PPPO-02-1168806-11

**TRANSMITTAL OF THE REVISED PROPOSED PLAN FOR SOLID WASTE  
MANAGEMENT UNITS 1, 211-A, 211-B, AND PART OF 102 VOLATILE ORGANIC  
COMPOUND SOURCES FOR THE SOUTHWEST GROUNDWATER PLUME AT THE  
PADUCAH GASEOUS DIFFUSION PLANT, PADUCAH, KENTUCKY  
(DOE/LX/07-0363&D2)**

**Revised Proposed Plan  
for Solid Waste Management Units 1, 211-A, 211-B, and Part of 102 Volatile  
Organic Compound Sources for the Southwest Groundwater Plume at the  
Paducah Gaseous Diffusion Plant, Paducah, Kentucky**

Figure 1. Location of Southwest Groundwater Plume

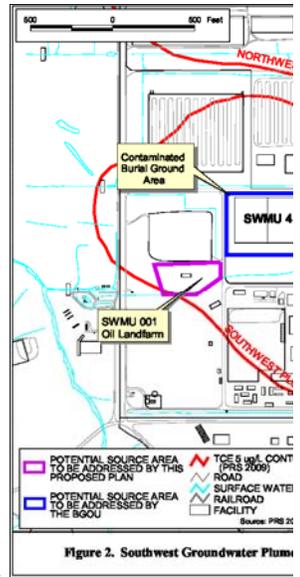
Comment [c2]: Combine Figure 1 and Figure 2; Add Figure 120/121 from the FS

Figure changes have been made as requested.
